**EASTSOUND SEWER AND WATER DISTRICT  
WASTEWATER TREATMENT PLANT UPGRADE – PHASE 2**

**ADDENDUM NO. 4 (3 pages total)  
Issue Date: March 14, 2025**

### **Sheet C6.3:**

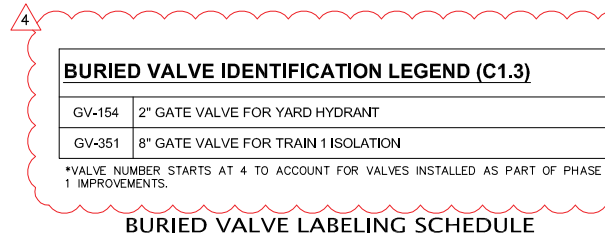
- Detail 1 has been updated to show the adjusted Buried Valve Identification Legend and the associated adjustment for Label Markers.
- Detail 5 - Yard Hydrant has been added. A yard hydrant will need to be added at the northwest corner of the dewatering building (Pipe ID #7 on Sheet C1.3). Yard hydrant will need to be connected to the existing 2" gate valve at that location.
